Product Change Notice

Part Series Affected: Mini MOX (MOX400,MOX750,MOX1125) and RX-1M Series

Effective Date: May 2nd 2022

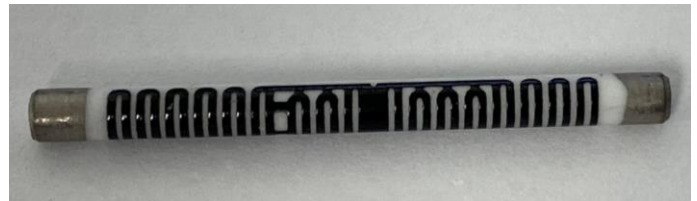
Starting May 2nd, 2022, the Mini MOX and RX-1M thick film resistor series will undergo a manufacturing process change. The application of thick film ink will change from a dipping method to printing method. This change increases yield, lowers lead times, and allows more precise application of ink to the substrate. This will be a running change applied throughout the part series and will have no effect on part performance.

OLD

NEW
